File SPR-1996-031

Name: Bookcliff Station Apartments – 960 Bookcliff Avenue

REVIEW COMMENTS

TITLE HEADING: Bookcliff Station Apartments

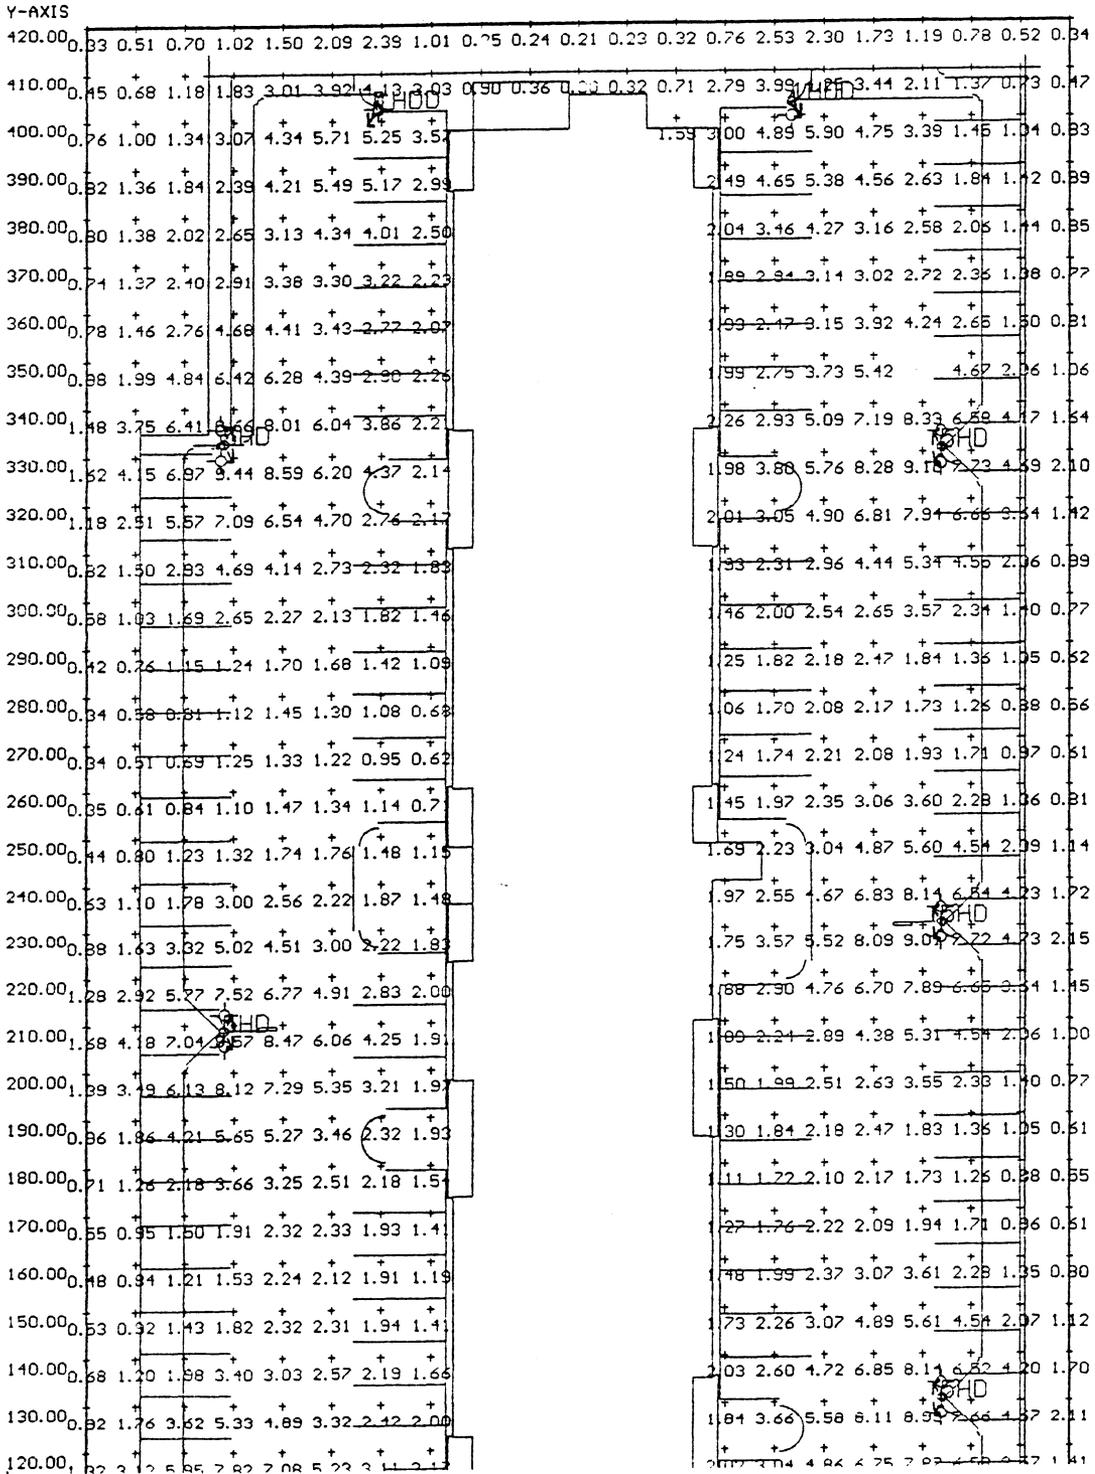
2. Parking lots currently have a dead-end design which is not acceptable. Need to provide some turn-around space at the end in order to back out of the last space.

The site plan will show that we are installing a landscaping type of paver to allow for emergency vehicles to drive from one side of the site to the other. Typically this area will appear to have been landscaped however these pavers have been designed to allow for vehicle traffic.

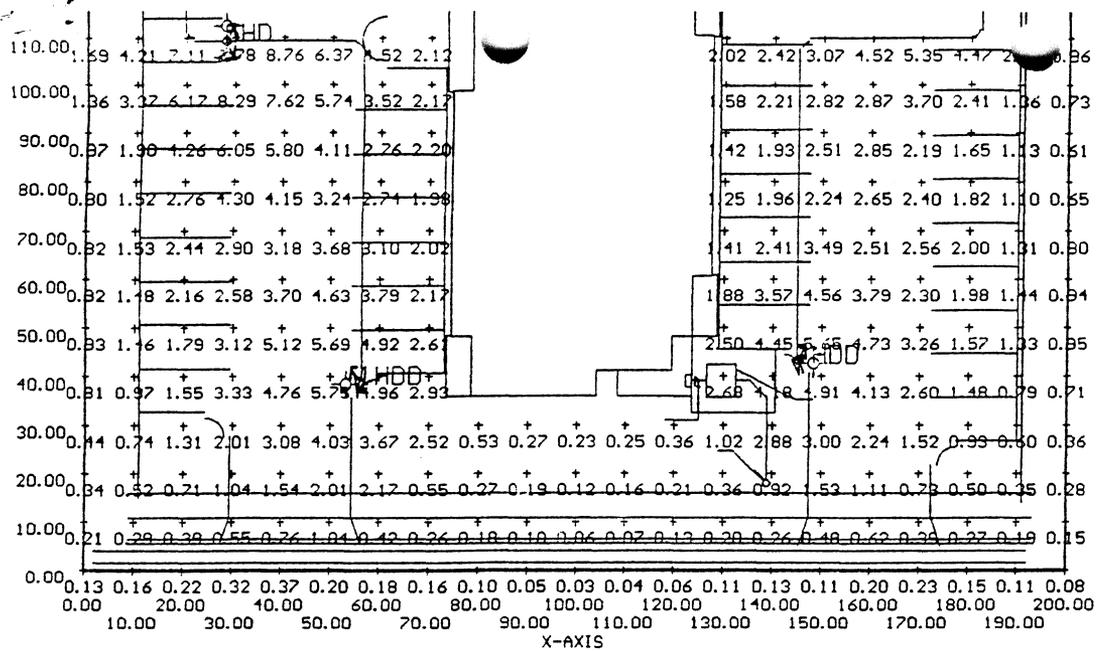
3. Bicycle racks sufficient to hold enough bicycles equal to 10% of the vehicular parking requirement are required.
4. There is no provision for trash collection. Need to show location of dumpster(s) and a detail of screening provided around them.

Bicycle racks have been added to meet this requirement.

A location has been provided for the dumpster.

SITE PLAN

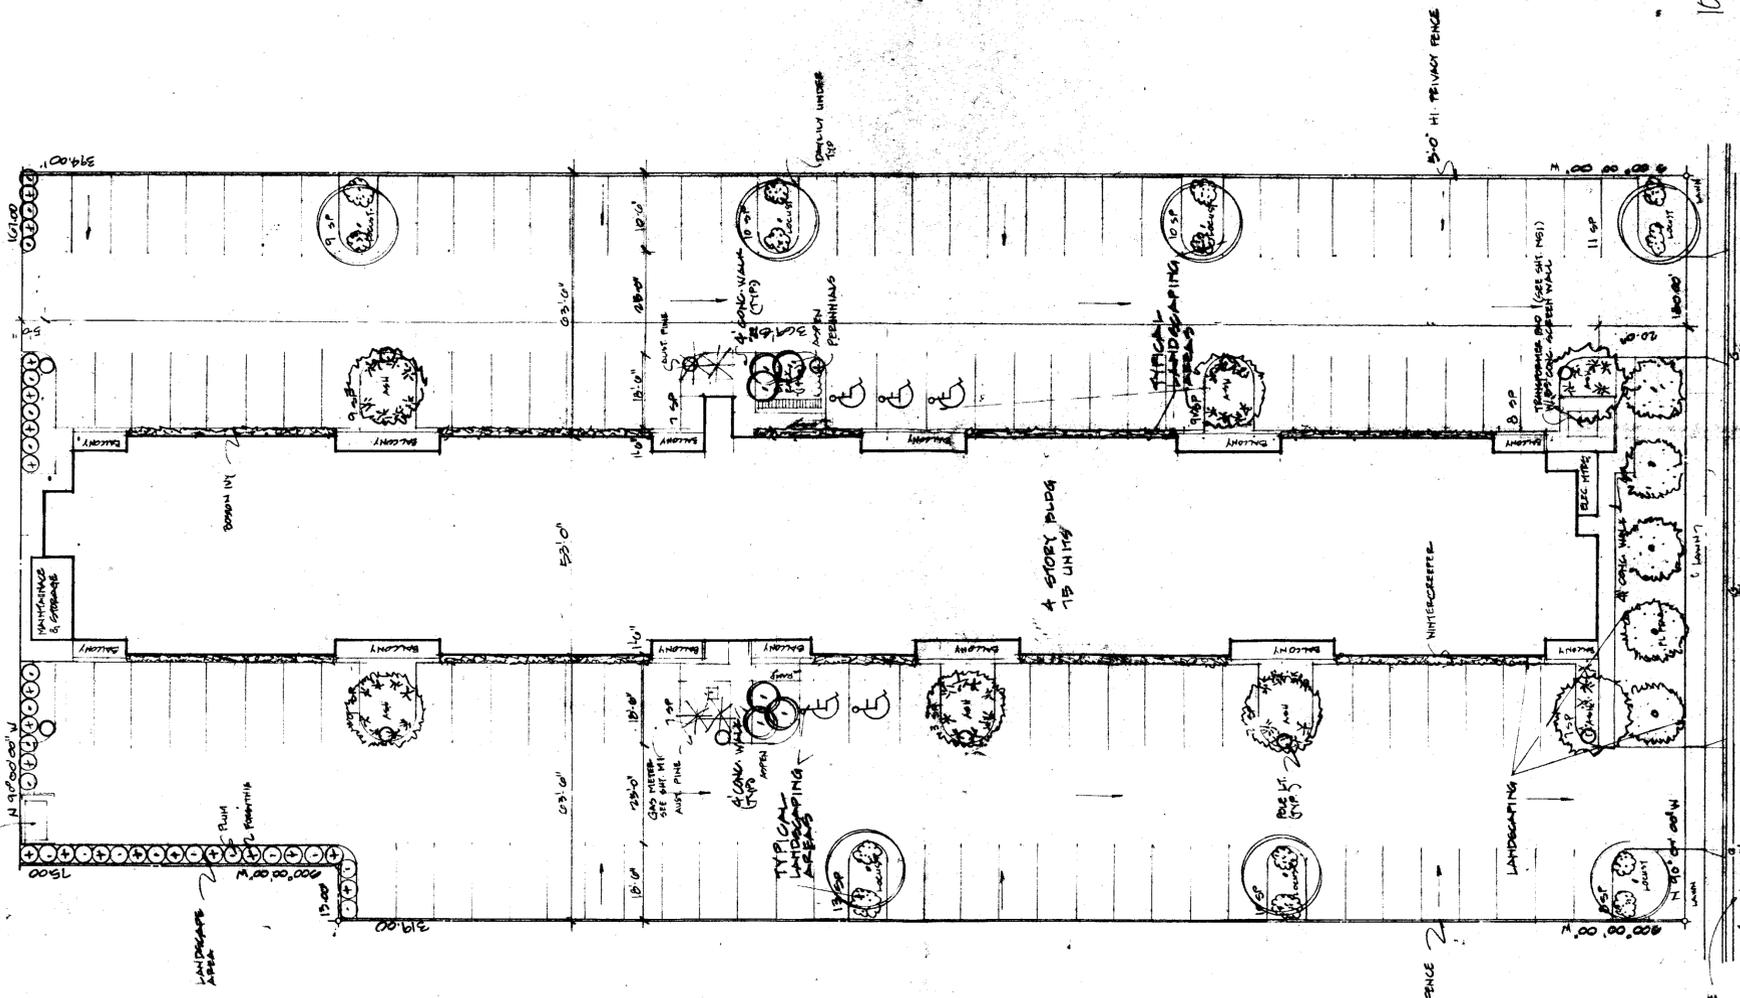
1. The plan appears to be trying to place too many units on the site--need to balance building coverage/parking/landscaping.
2. Since this property is comprised of 2 parcels, owner must execute and submit the enclosed form to ensure that the 2 parcels may not be split (sold separately) again.
3. Need to show evidence that right-of-way has been dedicated (Book 978 Page 711? or a copy of the Hartman Subdivision plat).
4. Provide a cross-section of a wall to illustrate how 8.5-foot floors will function.
5. For future information, sign allowance for the RMF-64 zone is 32 square feet and may contain only the building or complex name and name of the agent.

1. While the overall landscape requirement for the RMF-64 zone (15%) is met, the plan does not provide the additional landscaping required for large parking lots by section 5-5-1 F. of the Zoning and Development Code (see enclosed excerpt from Code).

F.2.b. Parking Area Perimeter Landscaping: The setback of all sides abutting a residential property must be landscaped (10 feet on east and west sides, 20 feet on the rear). Refer to Code for additional specifics.

F.2.c. Parking Area Interior Landscaping: 5% of net interior area must be landscaped. For each 100 square feet of this area, one tree must be provided. East side requirement: 1,299 sf/13 trees. West side requirement: 1,013 sf/11 trees. Plan does not meet this requirement.

Because the lot is narrow in nature and college housing requirements are fairly specific the density is 30% less than the zoning allows. I think that our revised site plan will show that parking lot requirements and the percentage of landscaping required exceeds the cities codes.

Interior landscaping has been modified to meet your requirements.
